PRODUCT CHANGE NOTICE

SUBJECT: Insulation Case Change
 Product: Electric Double Layer Capacitor(Gold Capacitor)
 Series: NF-/F-/RF-Series
 P/Ns: EECFxxxxxxx
 EECRFxxxxx

EFFECTIVE DATE: Jan. 1, 2011 (Running Change)

Insulation casing

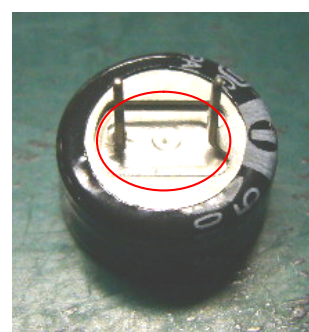
Material and color of the Insulation Case

Current
 PP(pigment contained) Color: White

New
 PP Color: Clear
